# SERVICE BULLETIN

**BULLETIN: 04-06**

**SUBJECT: 42C AFT SALON WINDOW BREAKAGE**

**HULL #s: STNAF259E506 through STNAF272A606**

Picture 1

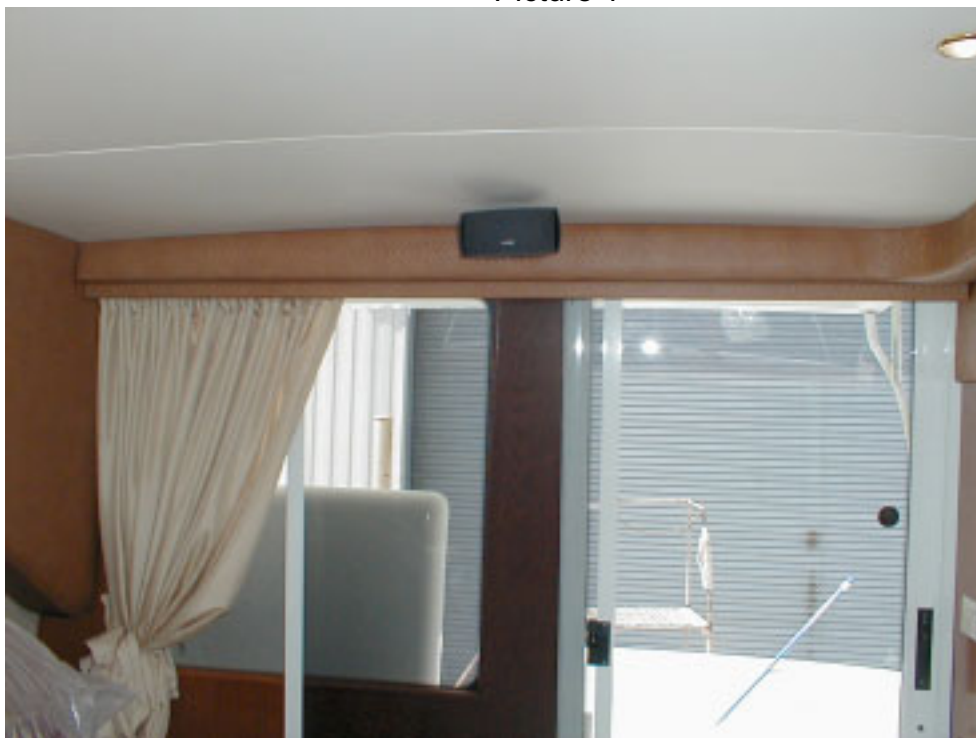
There is a possibility that some screws were incorrectly installed in the aft bulkhead of the 42 Convertibles described above. The boats listed **MUST** be inspected to determine if the screws are there and removed if found. **FAILURE** to remove the screws will result in breakage of the glass in the aft bulkhead. Follow the instructions to determine if the screws are present.

1. Remove the track for the aft entry door drape as shown in photo 1.
2. Remove the two screws as shown in photo 2 and set aside the headliner panel.
3. Remove the screw securing the entry door track to the bulkhead directly over the aft window.
4. Inspect for the three screws behind the aluminum entry door track and remove if there.
5. Reinstall the screw to secure the door track.
6. Reinstall the headliner panel.
